OHIO TURNPIKE AND  
INFRASTRUCTURE COMMISSION

ADDENDUM NO. 2

PROJECT NO. 39-17-01  
MAINLINE PAVEMENT RECONSTRUCTION  
MILEPOST 90.00 TO MILEPOST 95.90, EASTBOUND  
SANDUSKY COUNTY, OHIO

MODIFICATIONS TO THE CONTRACT DOCUMENTS

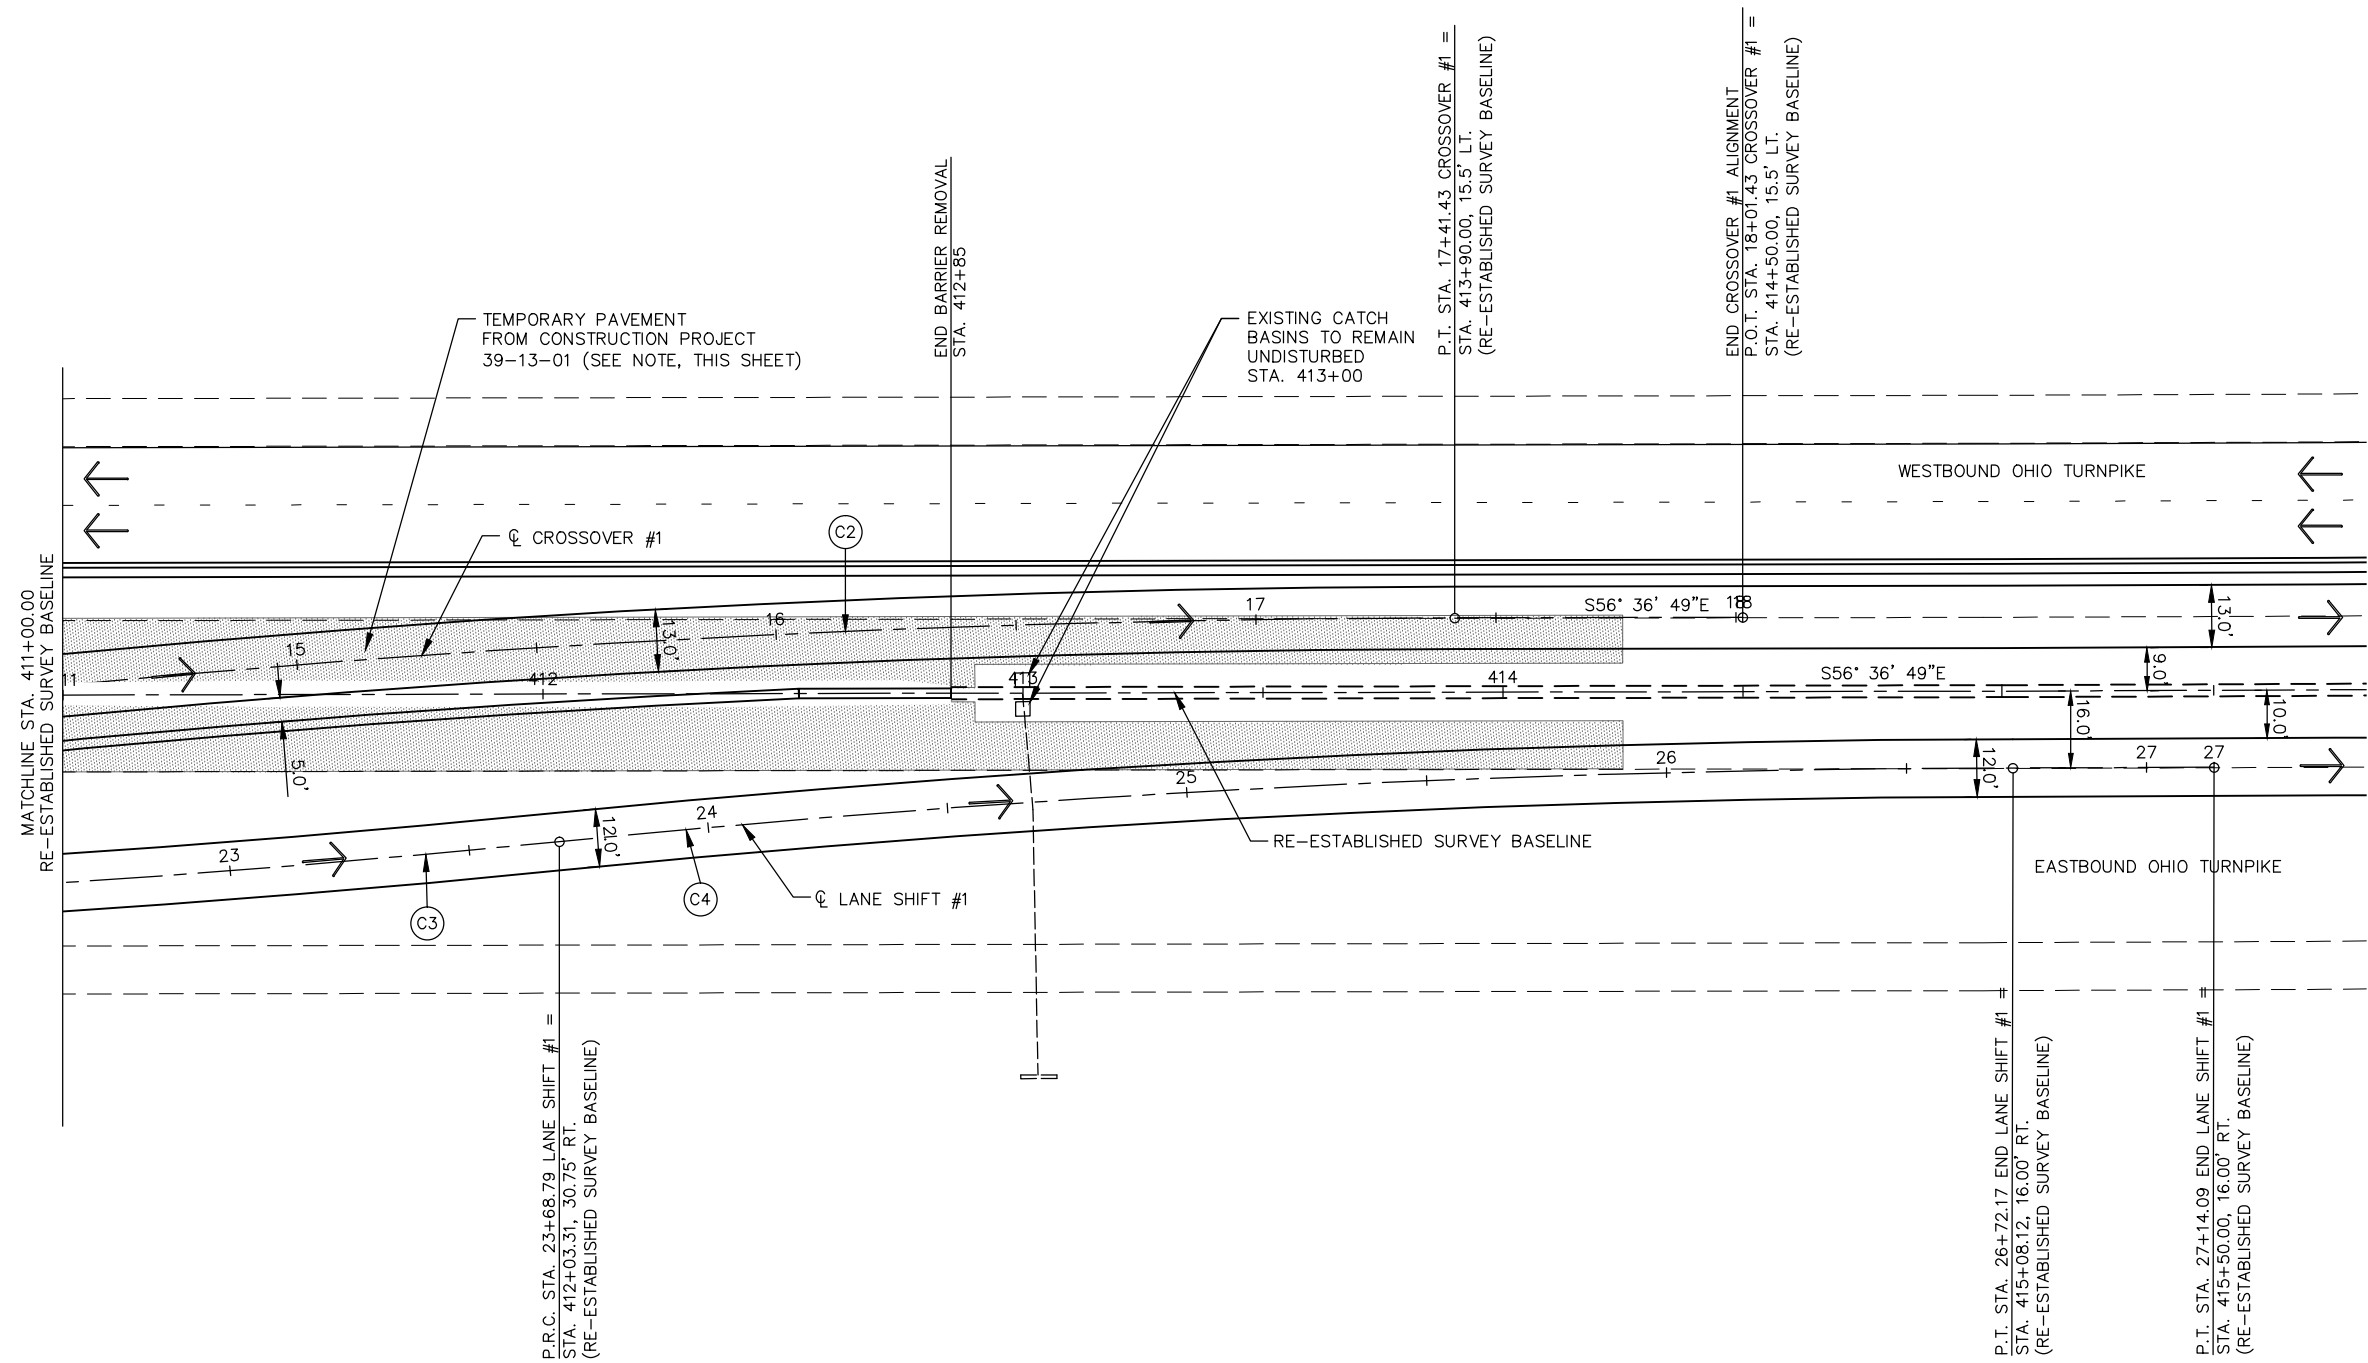
**Q#31** Plan sheets 93-96 provide details of the crossover at MP 90.0; Please clarify the intent of the 2<sup>nd</sup> paragraph. If it is required that part of the existing asphalt be removed and replaced to repair, should this be covered under Item 251 Partial Depth Repair or will asphalt wedging be required for smooth transitions for traffic?

*A#31 This Addendum No. 2 removes “This Item shall also be used for crossover pavement repairs, and as directed by the Chief Engineer” from the “Item 614 – Asphalt Concrete for Maintaining Traffic” General Note on Plan Sheet 19 of 272 and removes the same second Paragraph of the Notes on Plan Sheets 93 through 96 of 272.*

**PROJECT NO. 39-17-01 SHEET 240 OF 272**

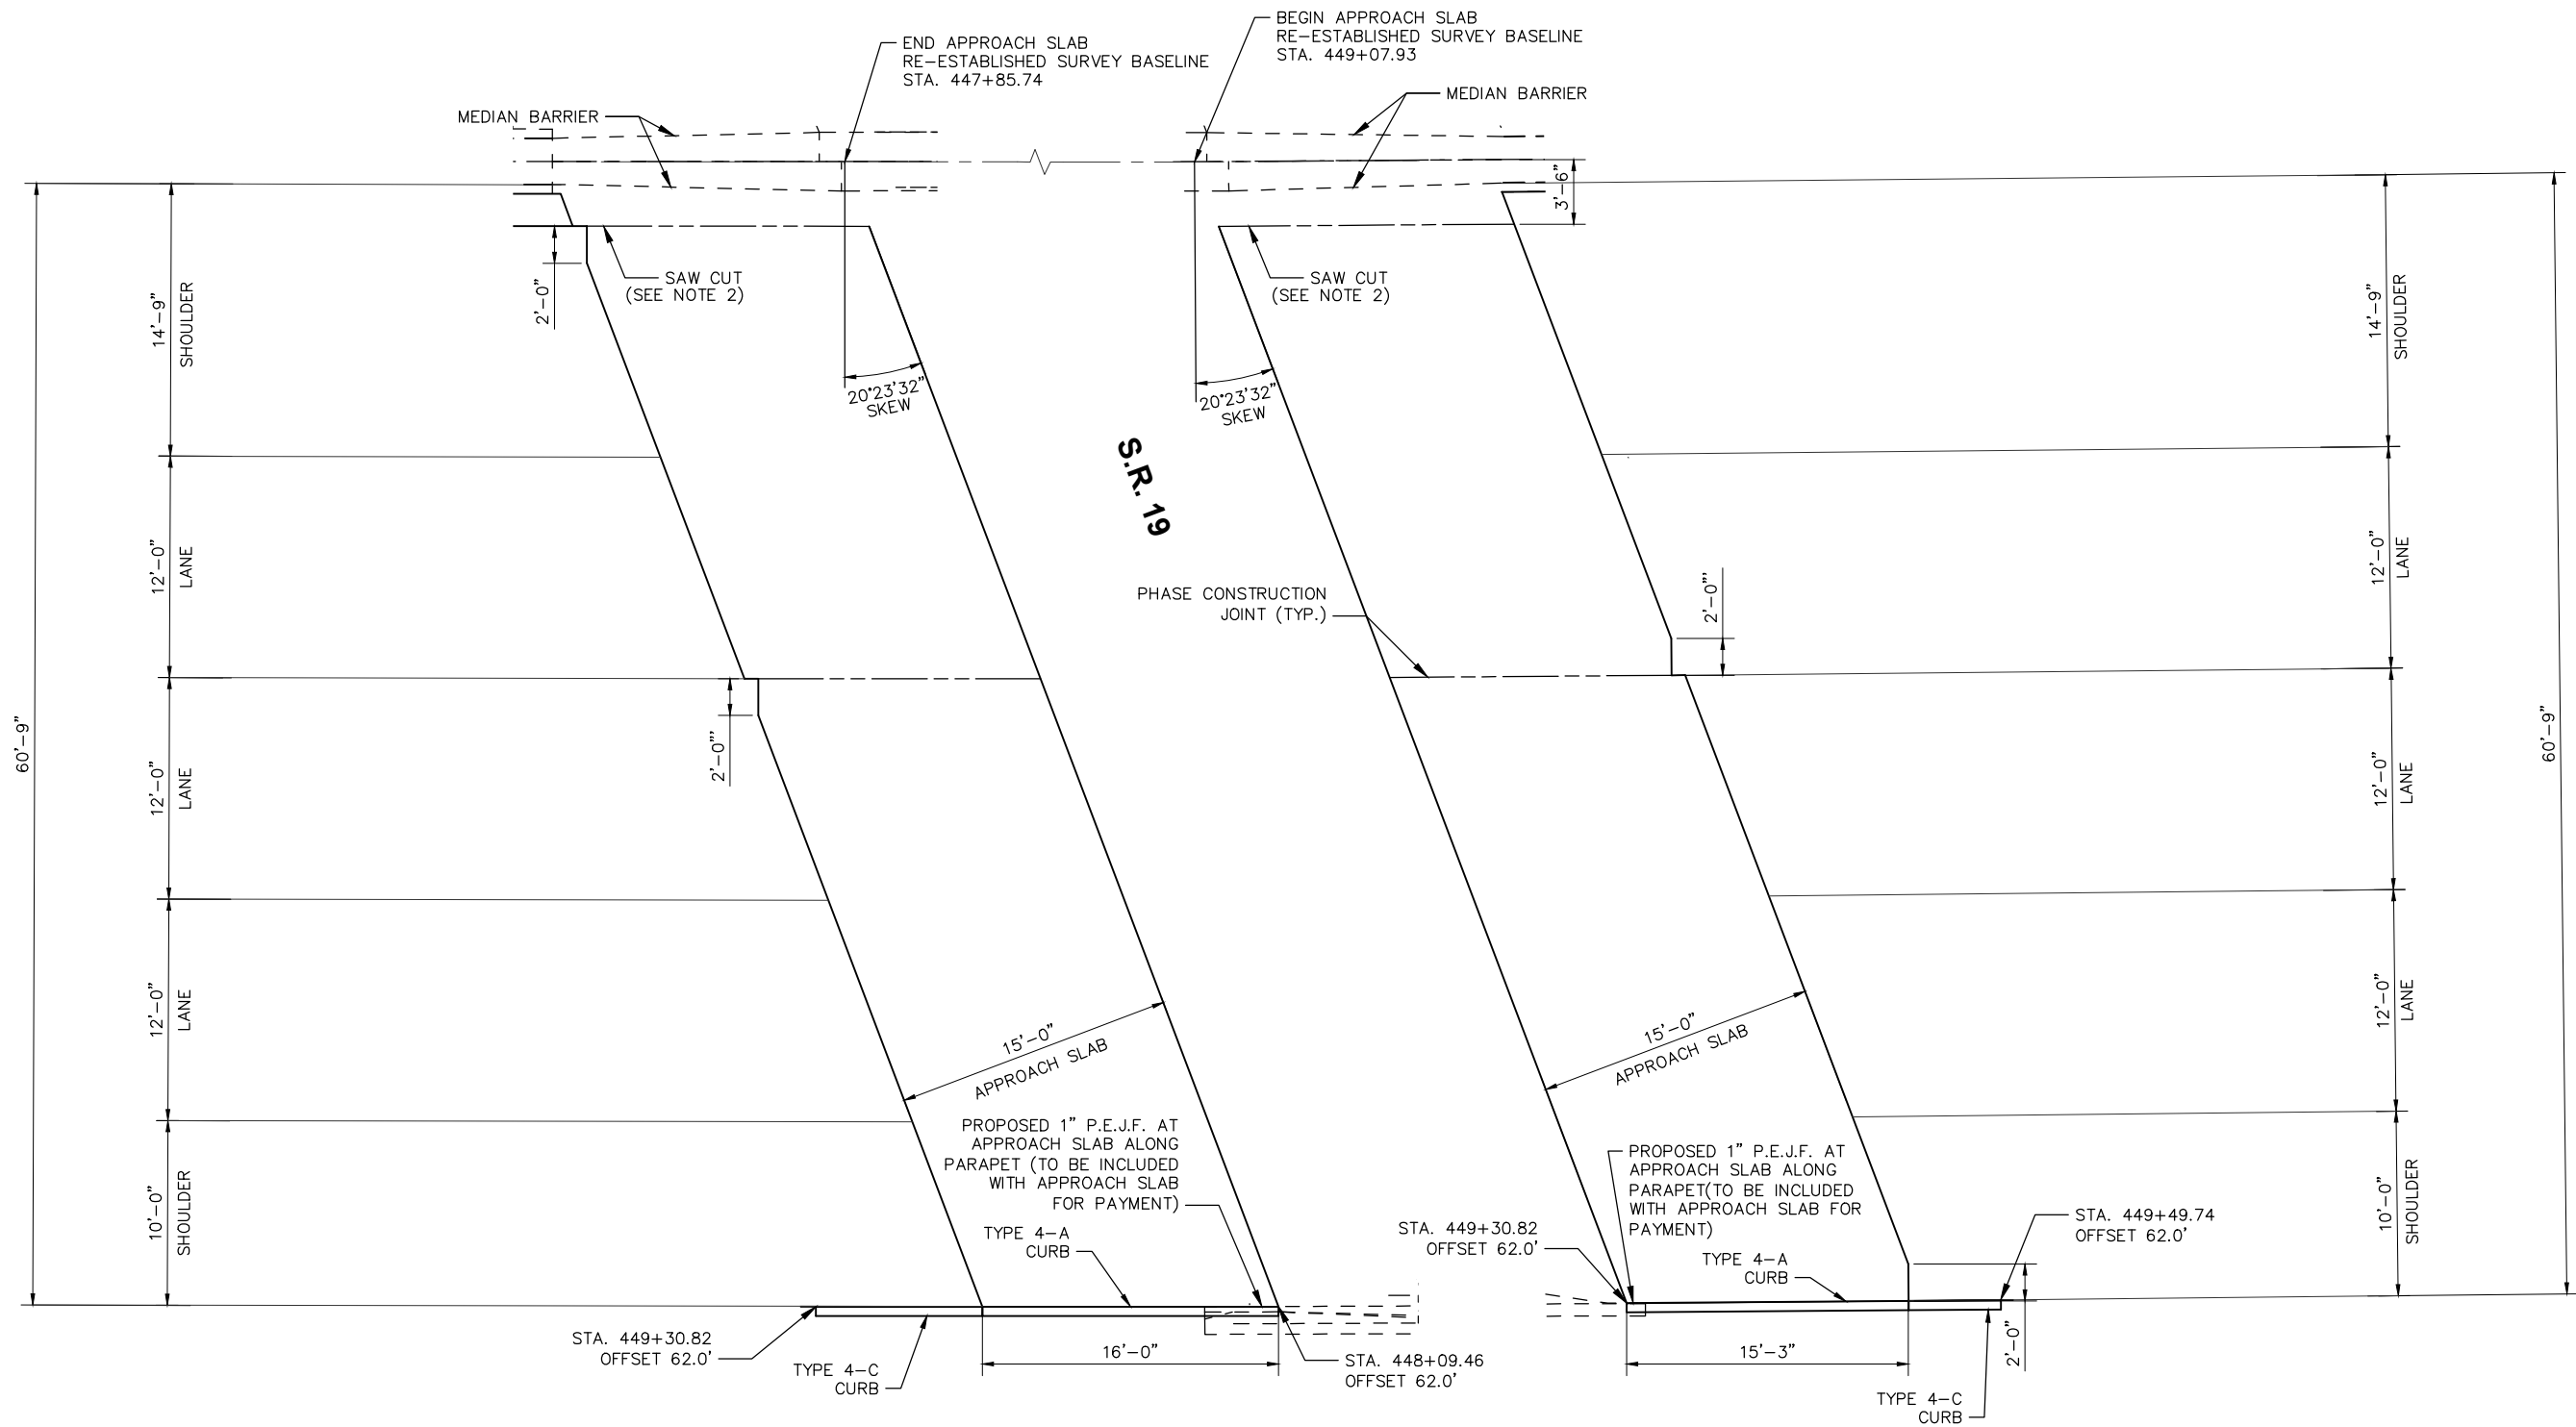
**Q#28** In looking at plan sheet 240/272 under notes # 3 it says “removal of existing approach slab is included under item 202- approach slab removed “. I cannot find a bid item for this in the proposal? This note is found on all sheets showing the approach slabs for bridges requiring removal and replacement. Please address.

**Q#32** In looking at plan sheet 240/272 under notes # 3 it says “removal of existing approach slab is included under item 202 - approach slab removed “. I cannot find a bid item for this in the proposal? This note is found on all sheets showing the approach slabs for bridges requiring removal and replacement. Please address.

*A#28 The removal of Approach Slabs is included in the Item 202 - Pavement Removed calculation as shown on Plan Sheet 110 of 272. This Addendum No. 2 revises the note 4 on Plan Sheets 240 through 246 of 272 from “Item 202 – Approach Slab Removed” to “Item 202 – Pavement Removed”.*
